Agenda Item

May 24, 2021

FROM: Chris Kerr, Community Development Director
Colin Cortes, AICP, CNU-A, Senior Planner

Because the proposal is for buildings totaling greater than 2,000 square feet (sq ft) in the CG zoning district, per subsection 3. it requires a Type III Design Review. Additionally, the applicant submitted the Type IV application type of Annexation, which per 4.01.07 cited above elevates the consolidated applications package to the highest level required among the individual application types. The applicant submitted site plans on June 7, 2019 and revised site plans through September 23, 2020 (within Attachment 103). (Staff hosted a pre-application meeting on May 1, 2019.)

Figure 3.01B – Major Arterial

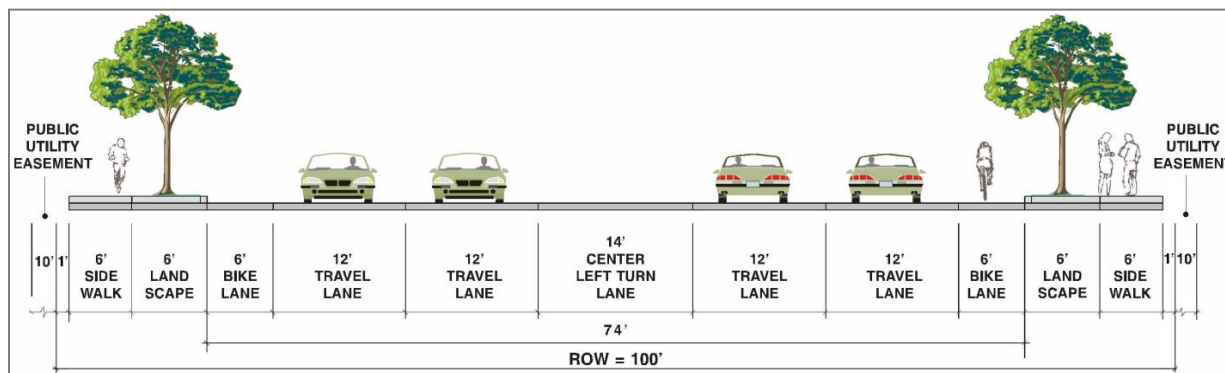
Frontage/public/street improvements are required to upgrade the frontages to present standards.

Because the planned ROW is 100 ft (50 ft “half-street”, each side of centerline), and the existing ROW varies from about 103 ft at the east to about 95 ft at the west (53 ft from centerline at the east and about 45 ft at the east), variable width dedication is required.

No roadside public utility easement (PUE) exists, and Figure 3.01B requires a 10-ft one.

D1. ROW: To meet WDO Figure 3.01B, as part of recordations and regarding OR 211, the applicant shall dedicate (a) variable width ROW resulting in half-street ROW that is uniform 50 ft wide min measured from road centerline, and (b) along the ROW a PUE 10 ft min.

Figure 3.05C - Parking Space Striping

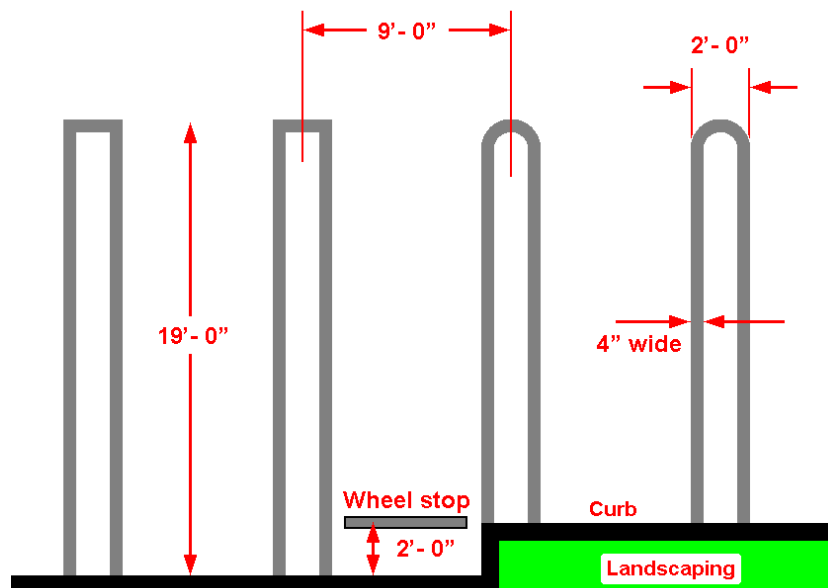
- a. Overhang: In parking aisles along the rear and sides of the subject property, standard size stalls shall overhang curbing and landscaping by 1 ft min, as WDO Figure 3.05C allows up to 2 ft max.
- b. Wheel stops: Wheel stops anywhere within the site development shall be 4 inches high max.

- a. Signage/striping: To meet WDO 3.05.02J, designate compact stalls "COMPACT" in lettering one 1 ft high min.
- b. Double striping: To meet WDO 3.05.02K, delineate parking stalls with double parallel lines pursuant to WDO Figure 3.05C.

TSP Figure 6

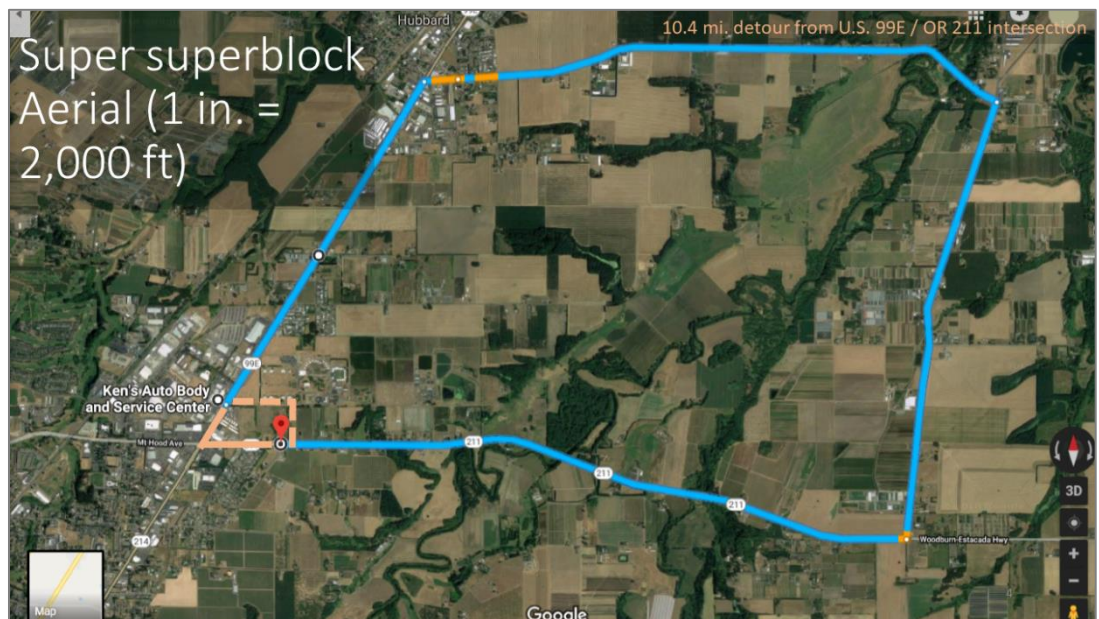
As examined under the Design Review Provisions section for 3.01, TSP Figure 6 calls for street connections among U.S. 99E and OR 211 at Cooley Road and June Way.

"Superblock" exhibit staff produced for Pre-App PRE 2019-01 that was February 13, 2019
(Note: Ignore the scale indication within the image.)

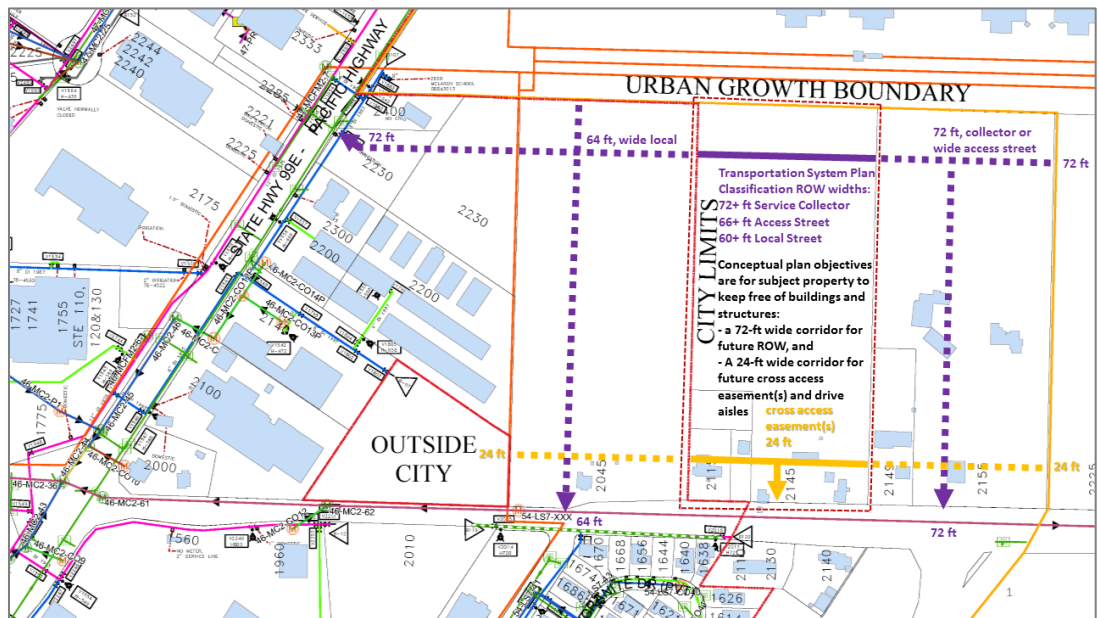
The superblock exhibit shows that looking beyond the UGB, the subject property is part of a gigantic superblock through which there are no streets or rural roads such

that the only alternative to passing along U.S. 99E and OR 211 through their intersection is a 10.4-mile detour.

In the exhibit, solid purple is the segment on the subject property of what staff later termed Street Corridor “C”, dashed purple indicates a sensible way to connect the three blue arrows that TSP Figure 6 shows, solid yellow line indicates provision on public cross access easements on the subject property (except that the thinner north-south yellow line most to the east actually is the UGB), and dashed yellow line indicates public cross access easements on more lots along OR 211. (Background colored lines represent subsurface utilities and bluish-gray polygons are building footprints.)

From the beginning, staff advised the applicant based on the above concept that staff drafted to bring greater detail to blue arrows of TSP Figure 6. The concept is of course a diagram and not at the detailed level of a site plan, civil engineering plan, or construction drawing.

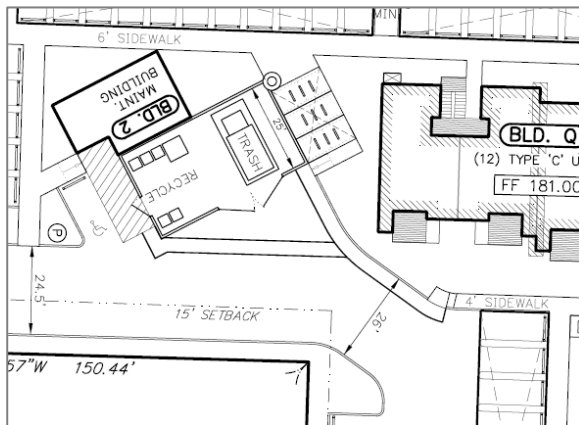
D2. Street corridor: To meet WDO 3.01, as proposed as part of recordations and regarding Street Corridor "C", the developer shall dedicate a PUE of 82 ft min width across the north end of the subject property, and shall revise the draft easement text to contain:

- a. In the body or an Exhibit C, a description that the easement serves to implement Woodburn Comprehensive Plan Policy H-2.2 and Transportation System Plan (TSP) Figure 6 (2019) by reserving on the subject property a segment of Street Corridor "C" for a future street that would connect Cooley Road and either or both June Way and U.S. 99E and that would be ROW of 72 ft width with remainder 5-ft PUEs along the south side or both sides; and
- b. One instance min of the phrase "street reservation and public utility easement" in any of the title, body, map Exhibit B, or an Exhibit C.
